AREA 1 FIELD SAMPLING PLAN
ADDENDUM TO REMEDIAL INVESTIGATION
WORK PLAN
FOR PER- AND POLYFLUOROALKYL SUBSTANCES
(PFAS)

FORMER FORT DEVENS ARMY INSTALLATION, DEVENS, MA

SEPTEMBER 2018

**U.S. ARMY RESPONSES TO U.S. EPA COMMENTS ON THE
DRAFT AREA 1 FIELD SAMPLING PLAN ADDENDUM TO
REMEDIAL INVESTIGATION WORK PLAN FOR PFAS
Former Fort Devens Army Installation, Devens, Massachusetts
8 August 2018**

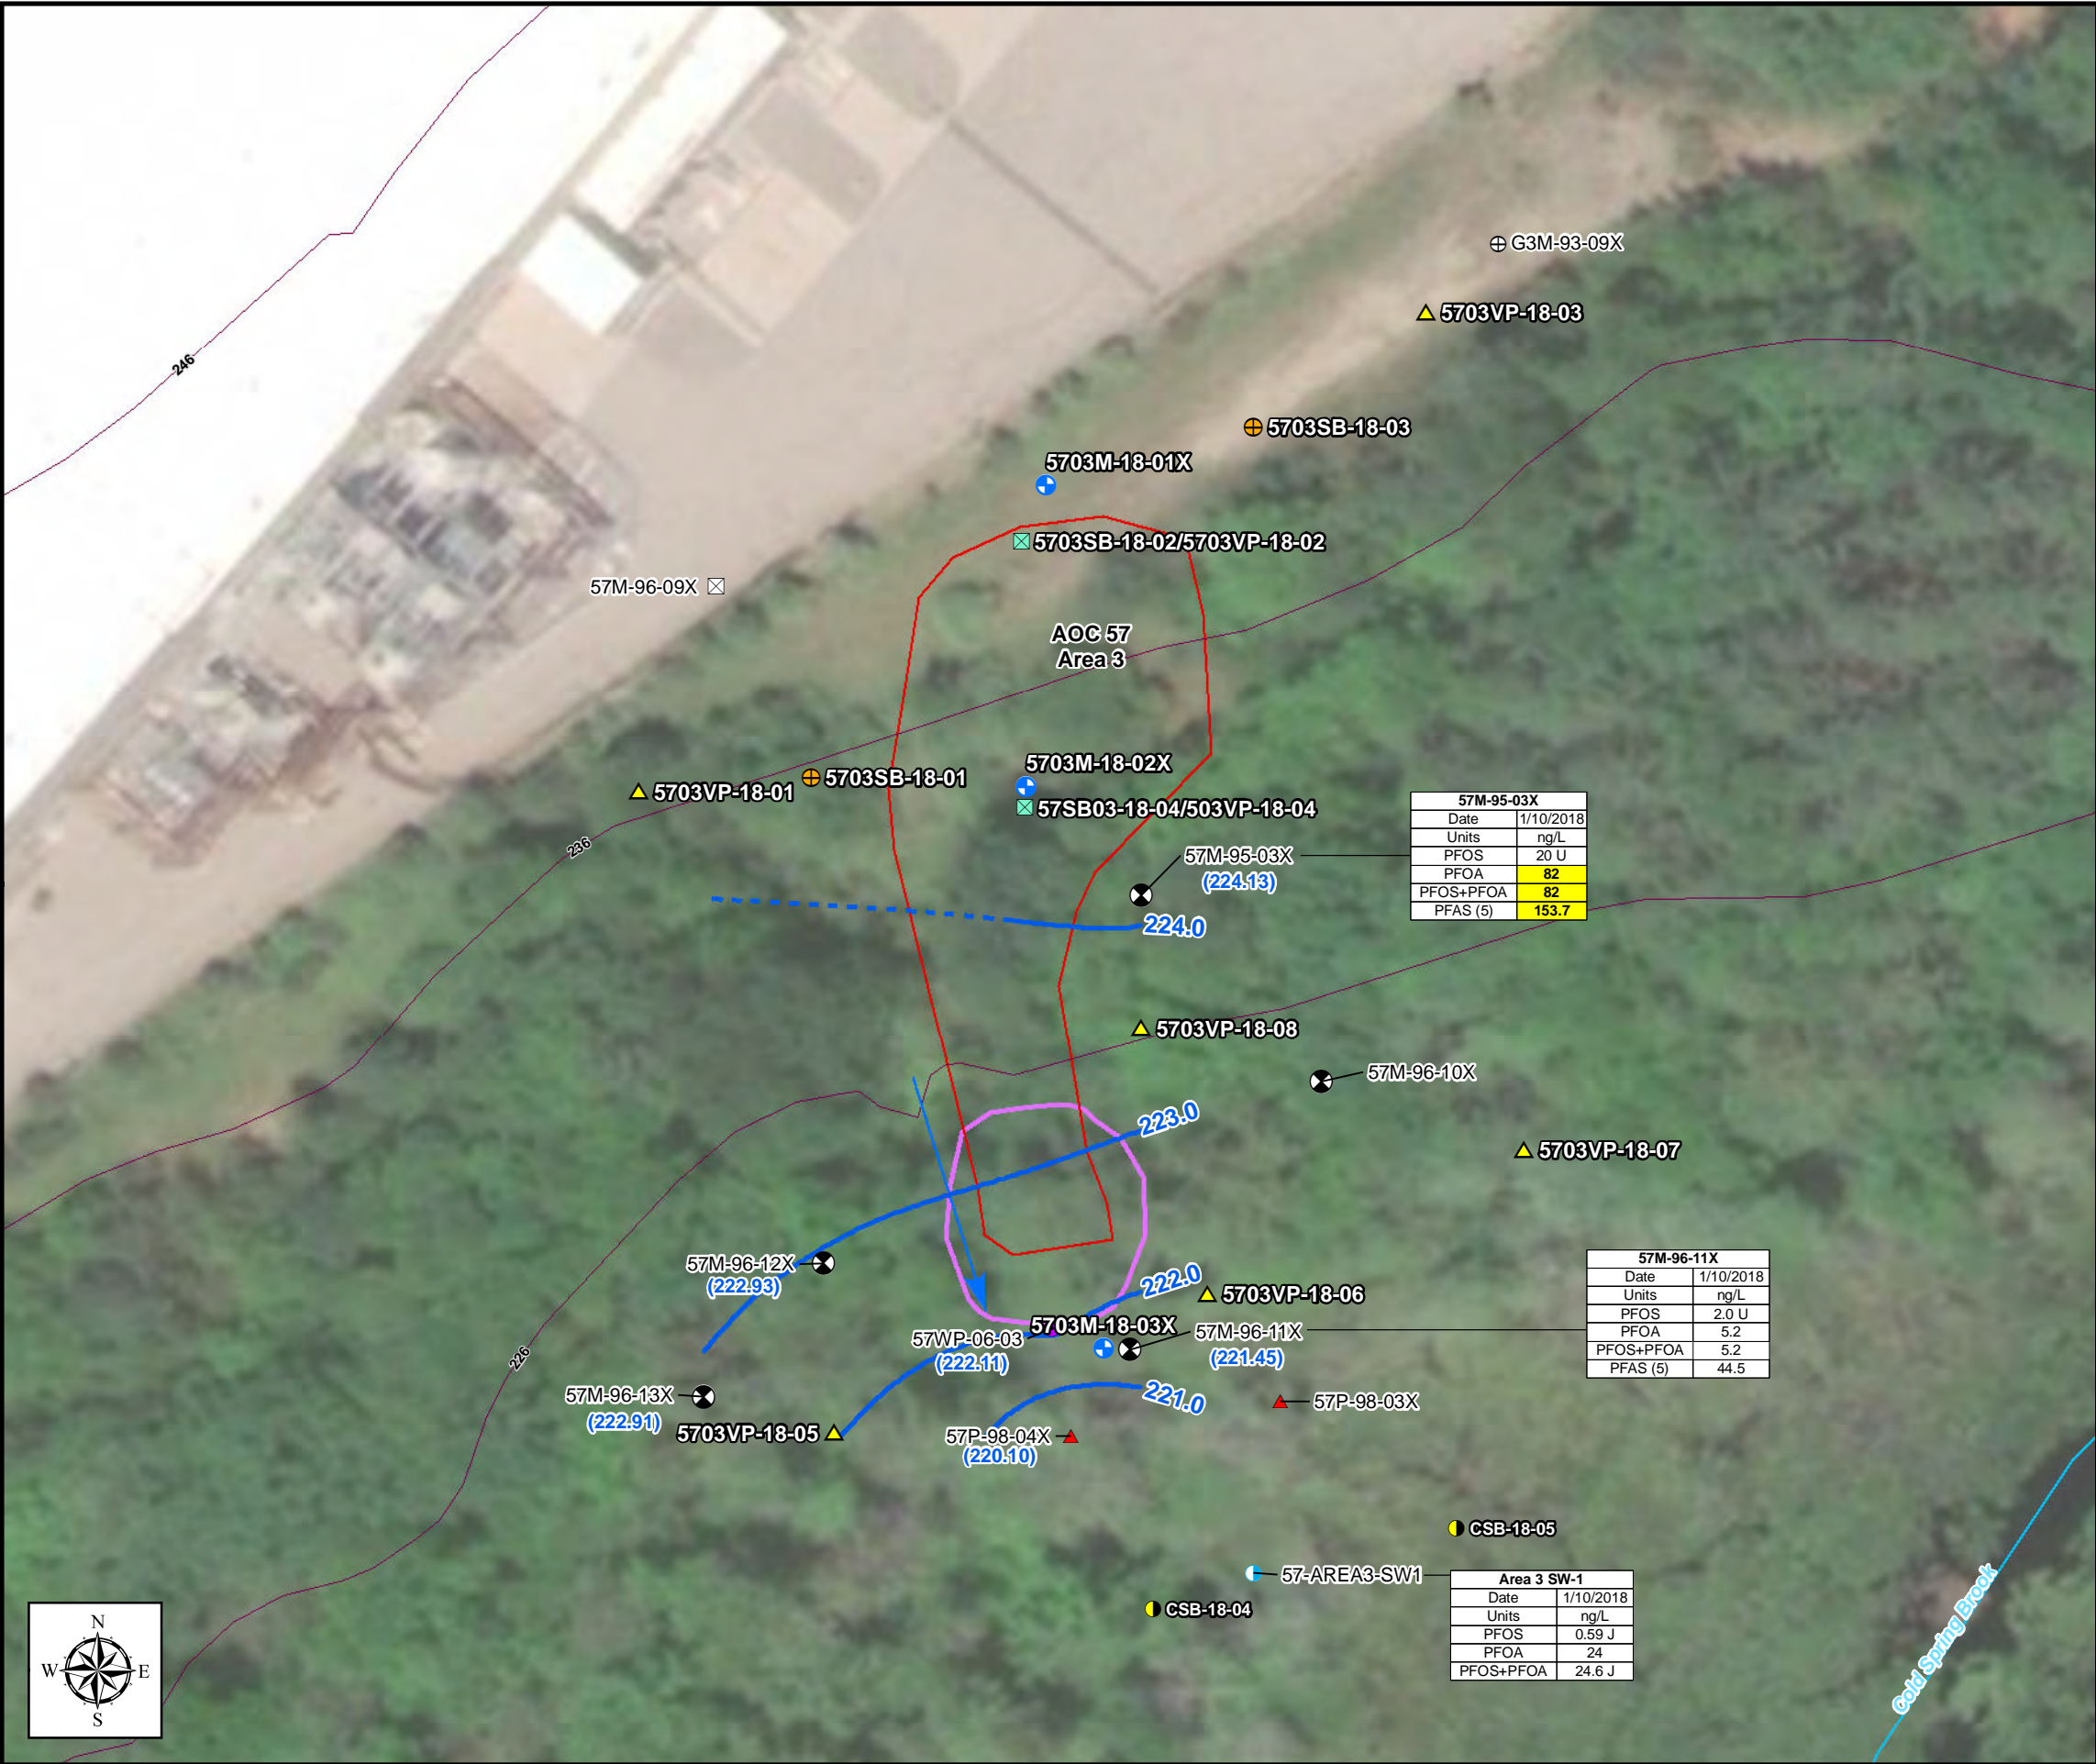
Comment #3: Figure 3: The proposed Area 2 surface water and sediment samples appear to be located on or adjacent to a containment dam. The samples should instead be collected from a location(s) most likely to be impacted by PFAS released from Area 2 as determined by proximity to source area, surface and groundwater flowpaths, and long-term monitoring surface water sample results. The conditions used to determine the sampling locations should be documented in the RI report.

Figure
4

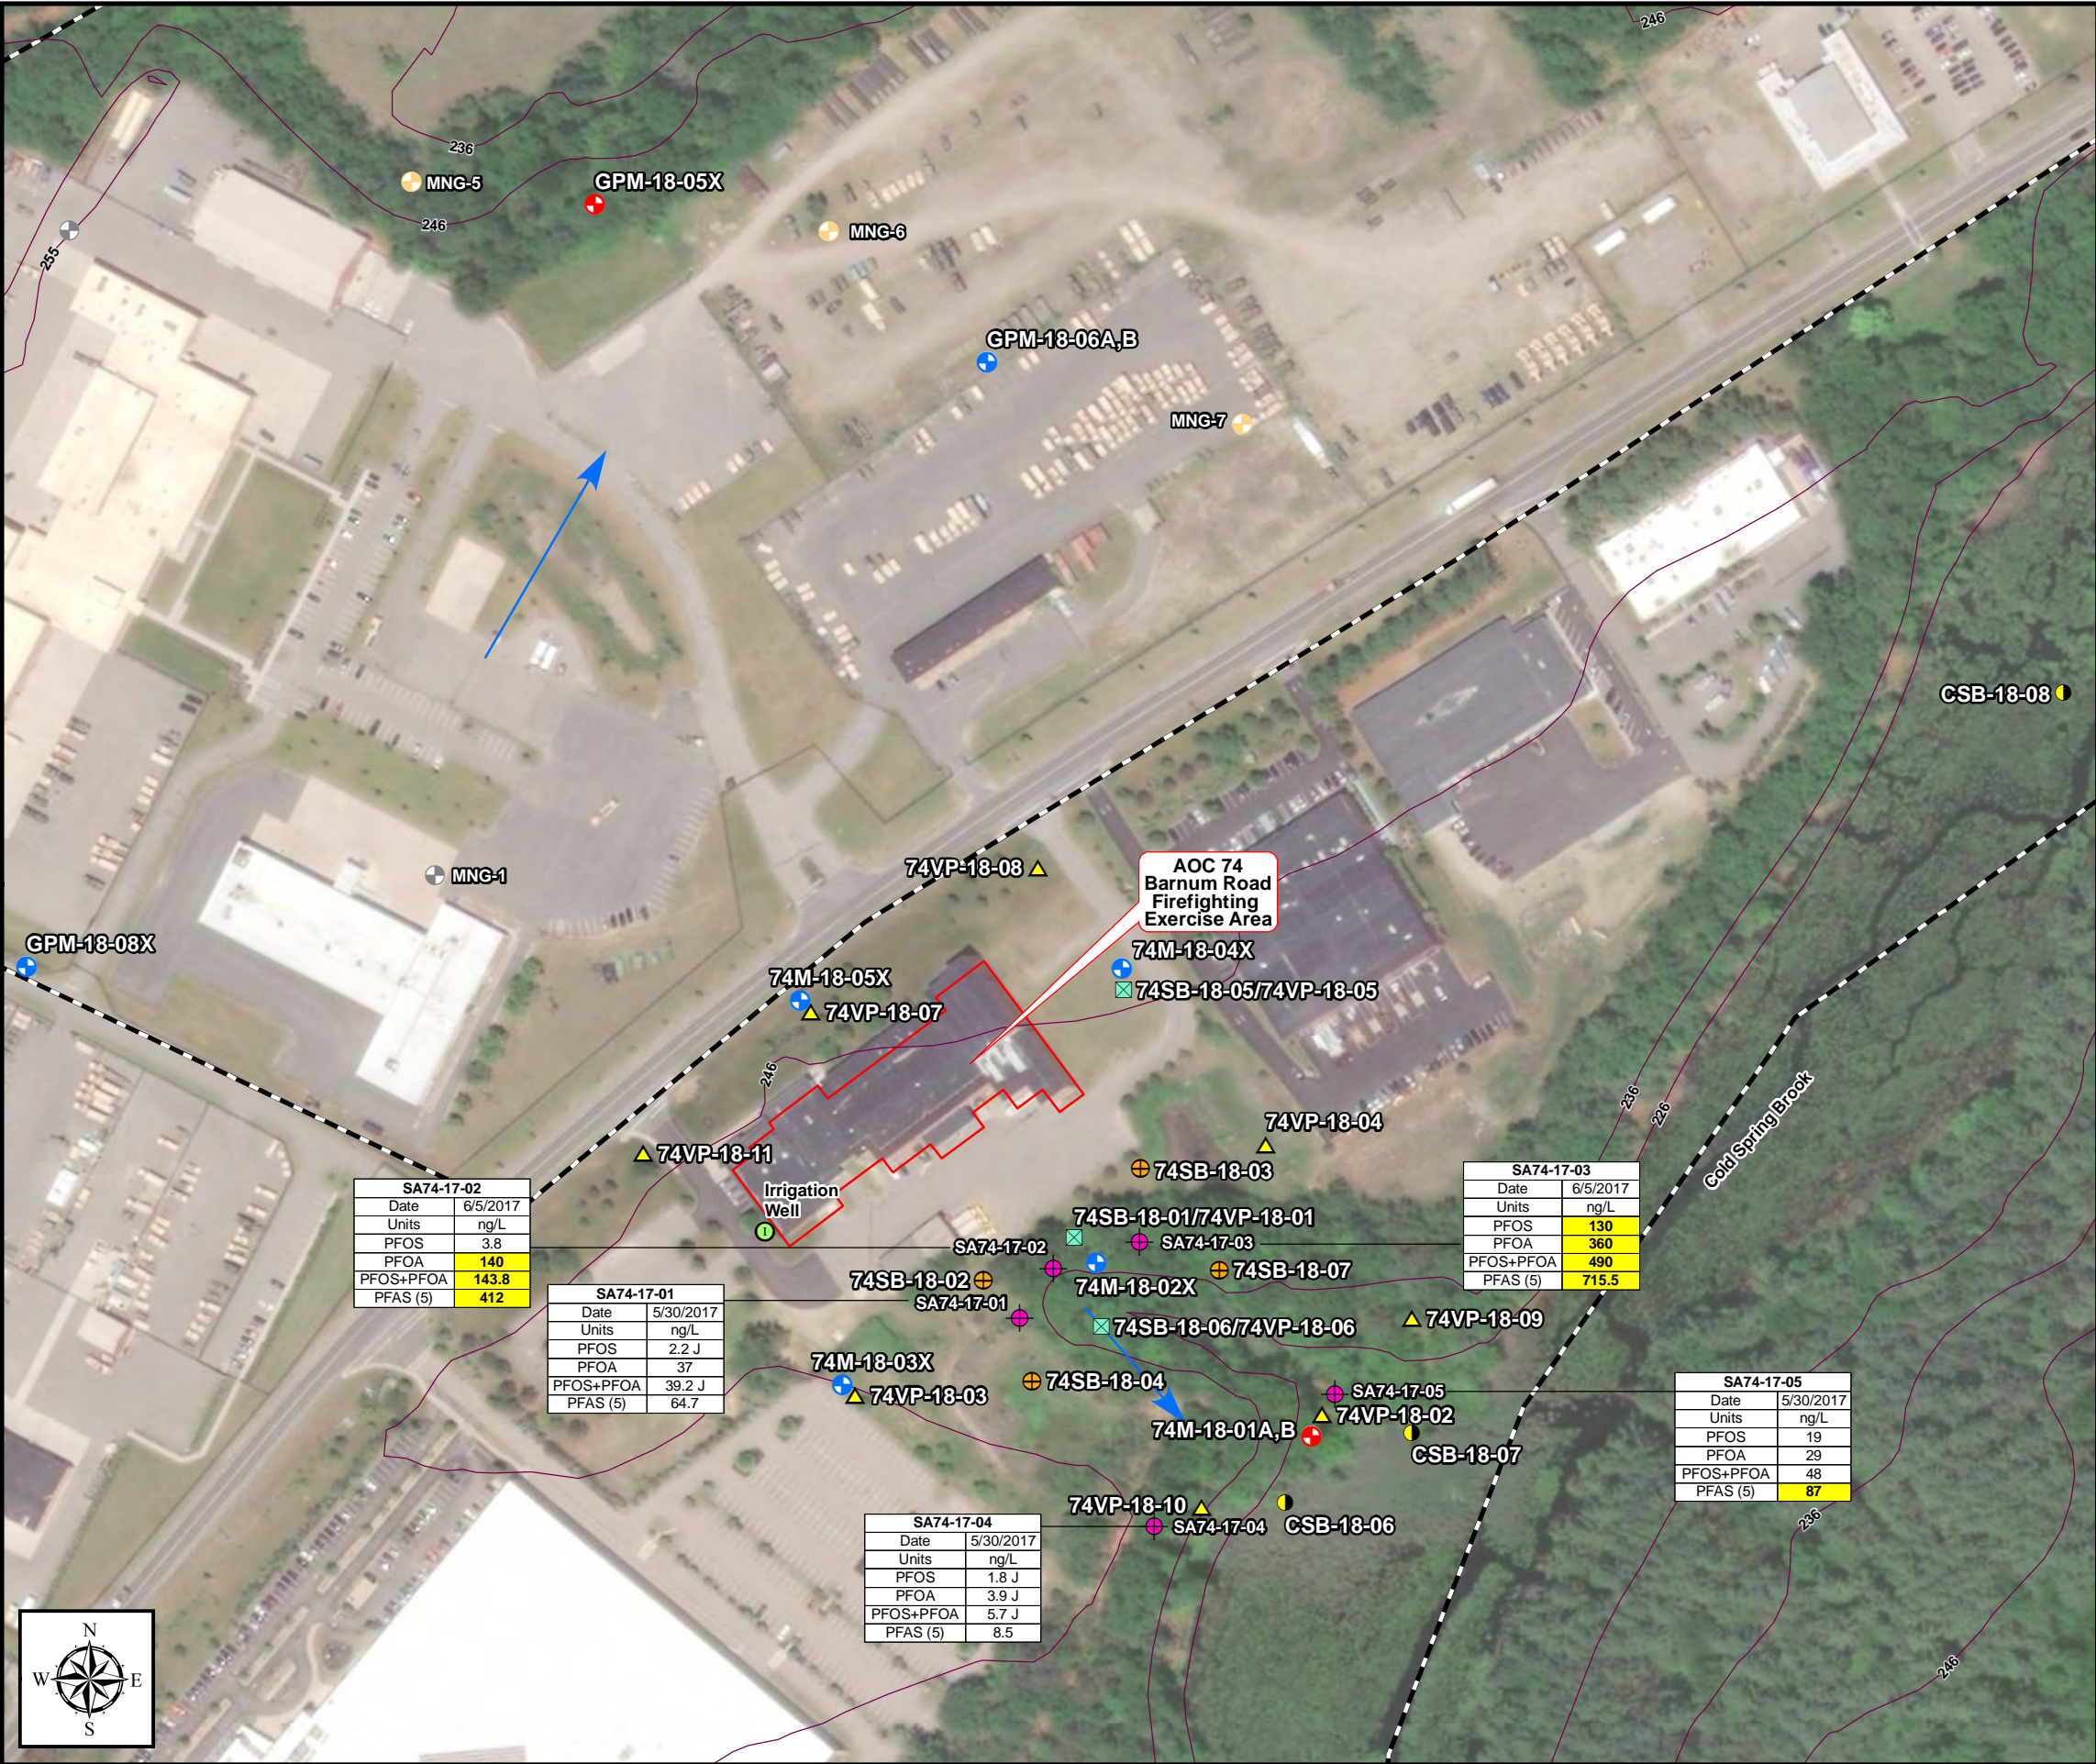
Comment #4: Figure 4: The Area 3 surface water and sediment samples should be collected from locations most likely to be impacted by PFAS released from Area 3 as determined by proximity to source area, surface and groundwater flowpaths, and long-term monitoring surface water sample results. The conditions used to determine the sampling locations should be documented in the RI report.
